WALDEN MEADOWS GARDEN HOMES UNIT 2
PRELIMINARY OVERALL AREA DEVELOPMENT PLAN/PLANNED UNIT DEVELOPMENT
ROADS/PUD

JOB NO. 3087 - 01
DATE MAY 1994
DESIGNER
CHECKED J.P. DRAWN O.R.
SHEET 1 OF 1

RE: Walden Meadows Subdivision POADP #415

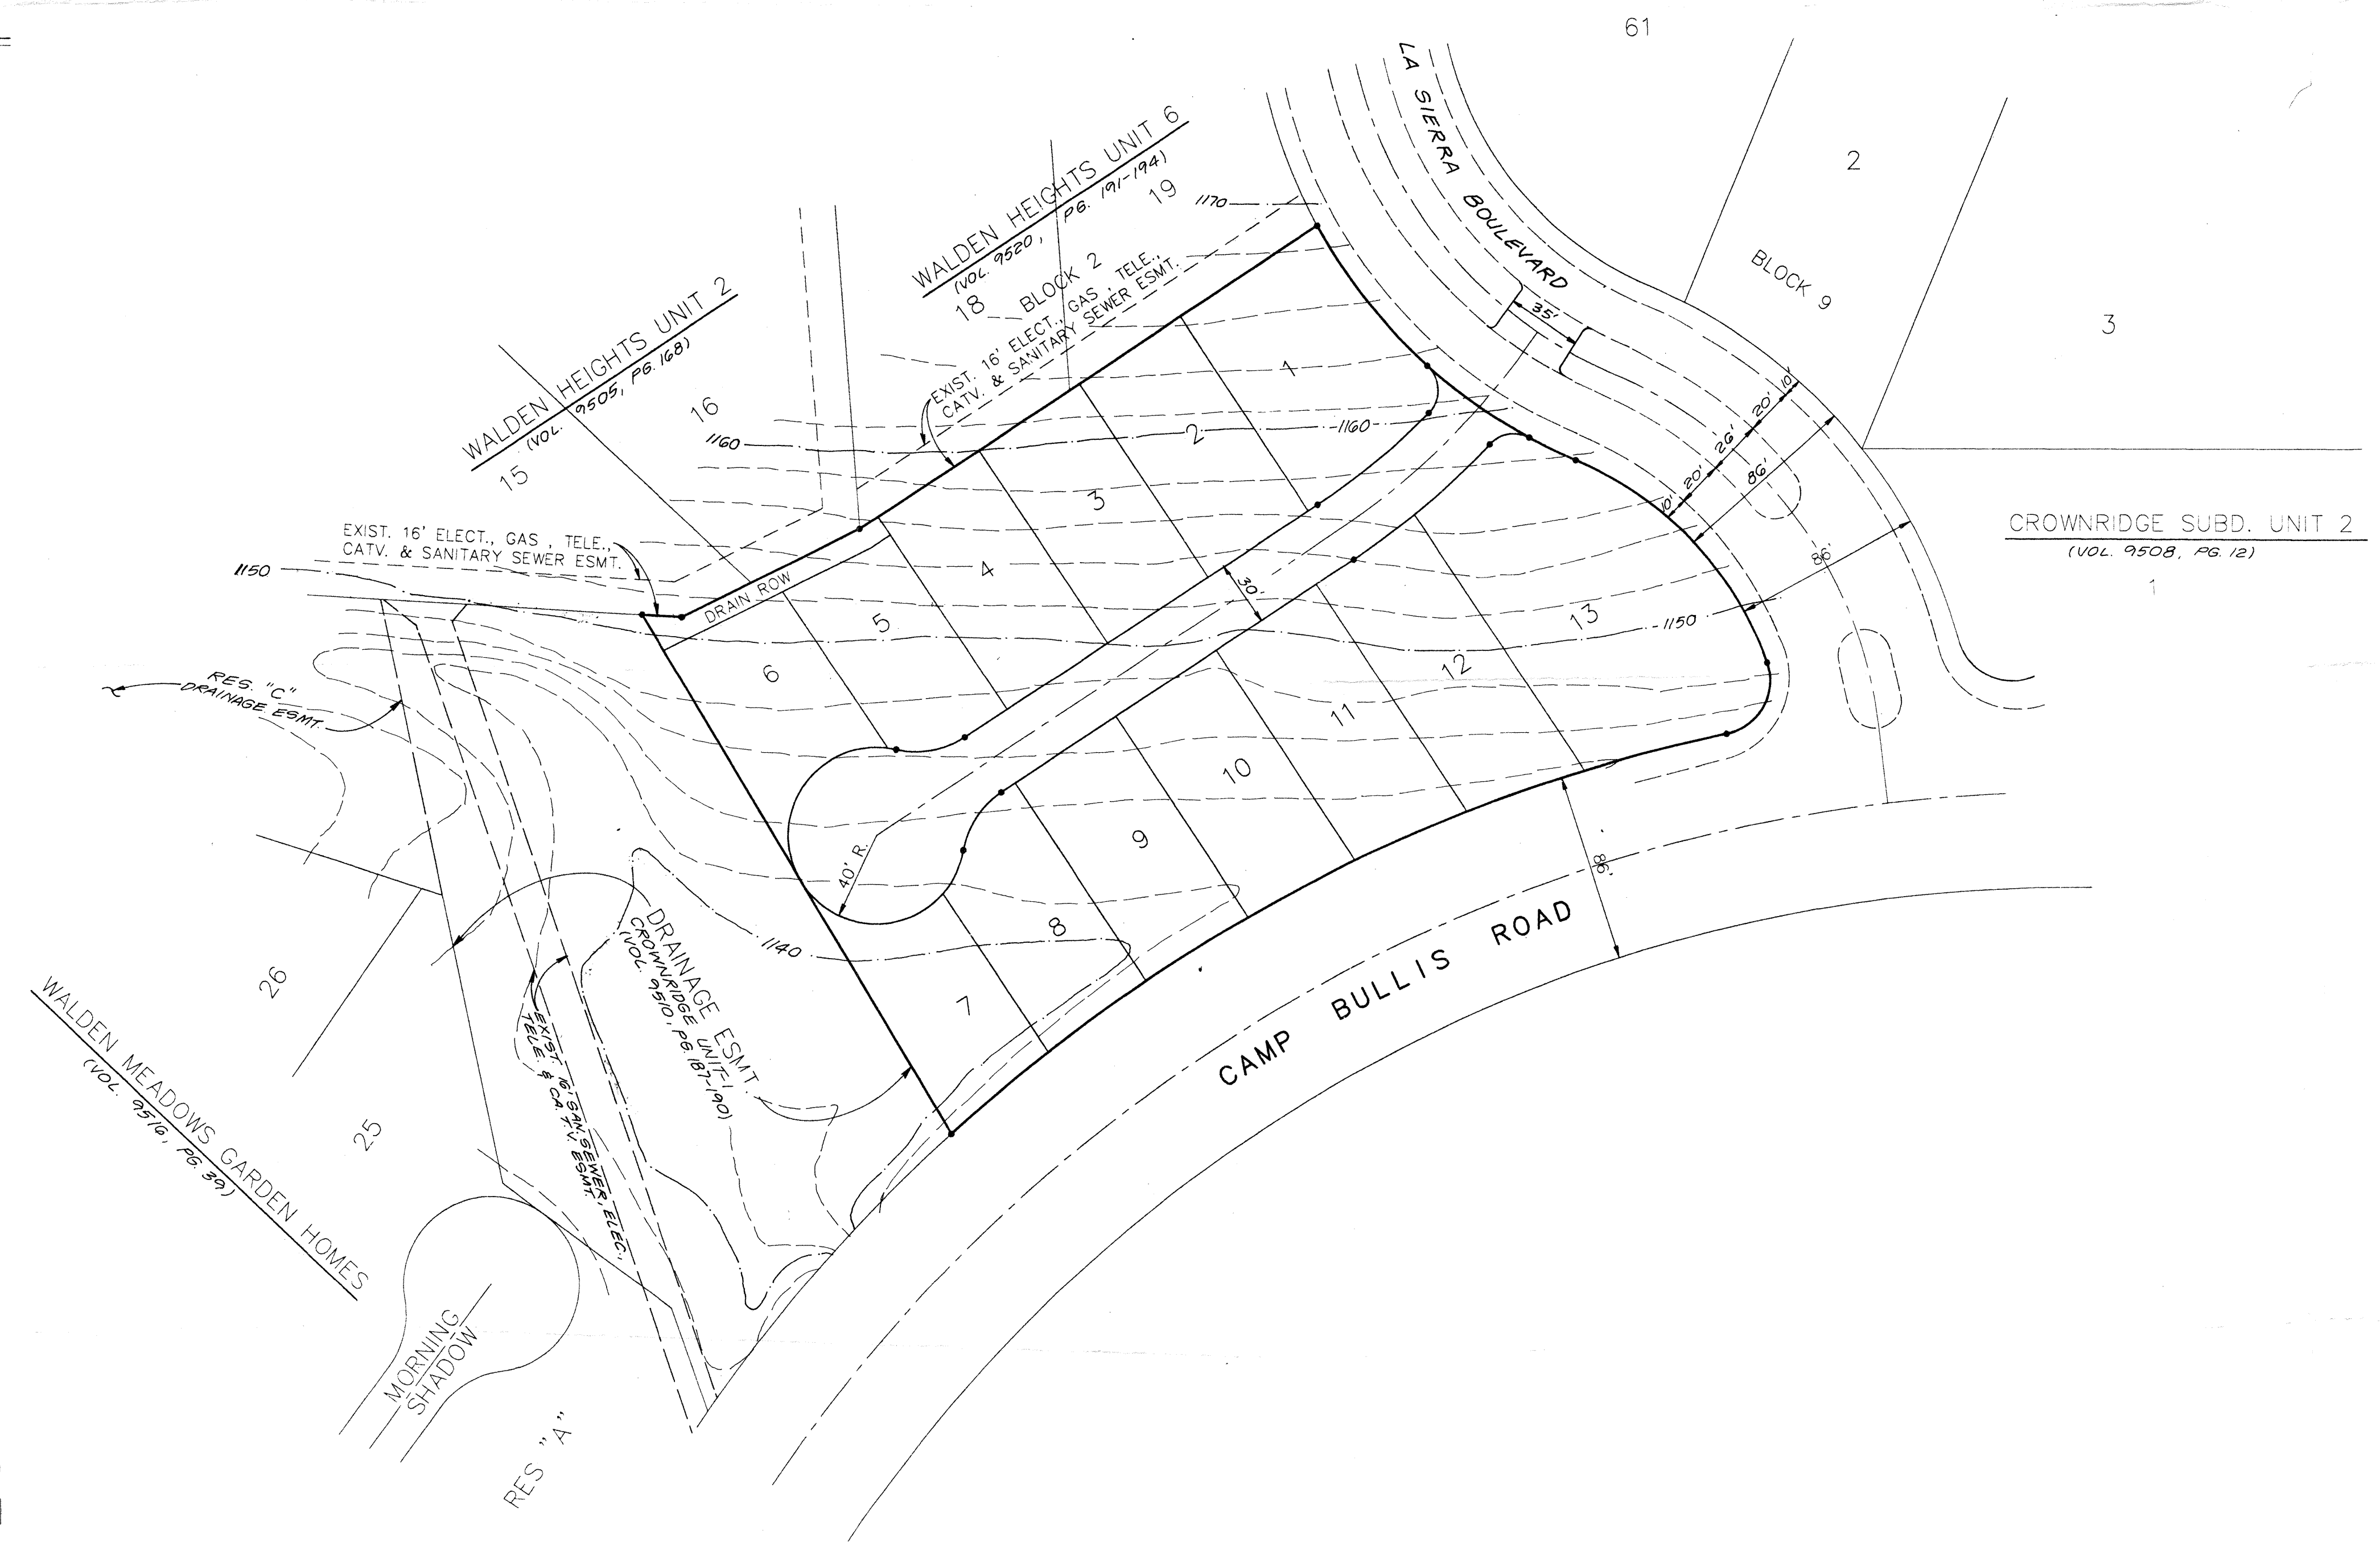
The City Staff Development Review Committee has reviewed your Walden Meadows Subdivision Preliminary Overall Area Development Plan #415. Please find enclosed a signed copy for your files. You may now submit individual subdivision plat units at your convenience. Although your plan was accepted, please note that a non-access easement will be required along the rear and sides of all residential lots adjacent to either La Sierra Boulevard or Camp Bullis Road.
